Date: February 14, 1995
To: ATA/ATAPI Committee
From: Jim McGrath (408-894-4504)
Subject: Problems with System Implementation of Dual Ports

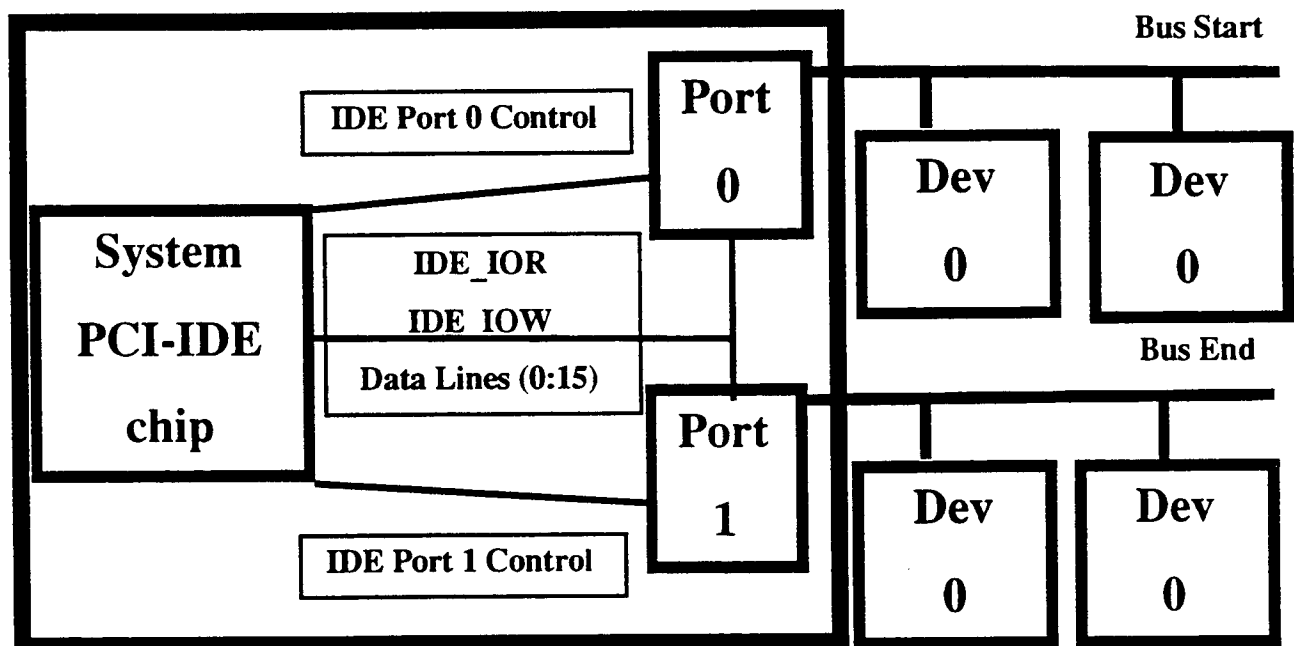
The restriction mentioned earlier on number of devices on a cable and length of a cable should really refer to "bus" not "cable." In the old, simple ATA world the bus was the cable (with some stubbing). But with 2 ports it is possible to create a system with 2 cables but one bus by multiplexing signals between the ports. Since the electrical restrictions apply to the bus, these systems will not work.

The figure below illustrates the problem. With IOR, IOW, and data multiplexed, the physical bus for these lines begins at the point marked "bus starts" and ends at the point marked "bus ends." It contains the two ATA cables and the traces on the system board connecting the cables to one another. Stubs are present at each device (4 stubs) and one in the middle of the bus to connect to the system chip. If the individual cables are 18 inches, then the total bus is 36-40 inches long (depending on the length of the traces on the system board) with 5 device loads. Under these circumstances the transmission line effects would generate errors for any device operating at Fast ATA speeds, and perhaps even at slower speeds.

This is one of the classic issues that is a system design problem impacting devices on the ATA cable. At a minimum people could spread knowledge of this issue, and pressure chip set vendors not to multiplex these lines. I believe notices in the ATA-3 standard (possibly an appendix) would help.

Alternatively, it is possible for system vendors to use external logic to fix this problem. In that case some guidance would be good, since I am sure any such design would otherwise be undesirable from a cost/complexity perspective.
